RE: SP-0086-2013, Kingsmill Riverwalk

Thank you for the opportunity to review your site plan application for the development of passive recreation path, amenity pier and boardwalk along the James River at the Kingsmill Resort. Upon review of your application, staff offers the following comments for your consideration:

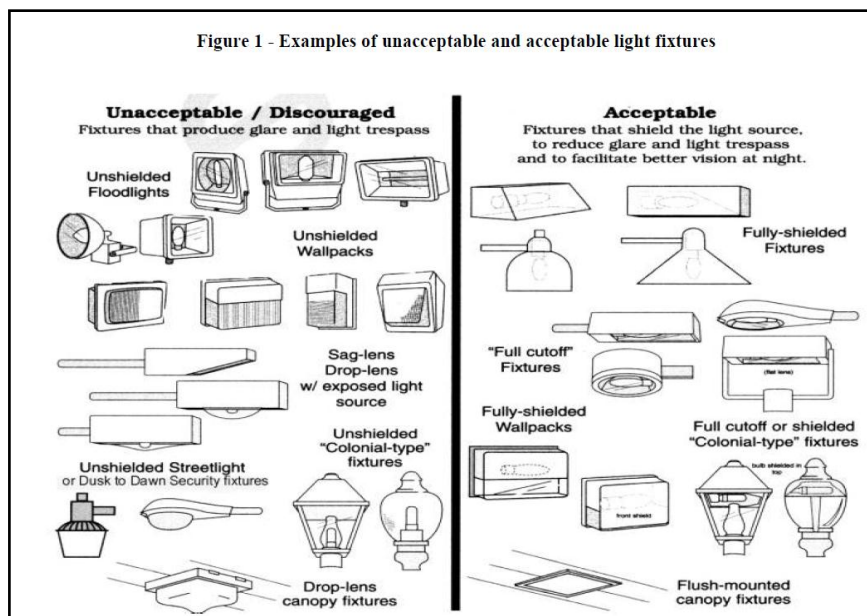
12. According to Section 24-132 of the Zoning Ordinance, all lighting shall be aimed, located, designed, fitted and maintained in a way that will not create a nuisance by projecting or reflecting objectionable light skyward or onto a neighboring use or property. Further, for the lighting of predominantly horizontal surfaces, light fixtures shall be full-cutoff fixtures that meet Illuminating Engineering Society of North America (IESNA) criteria, and shall be aimed straight down (see picture below for reference)
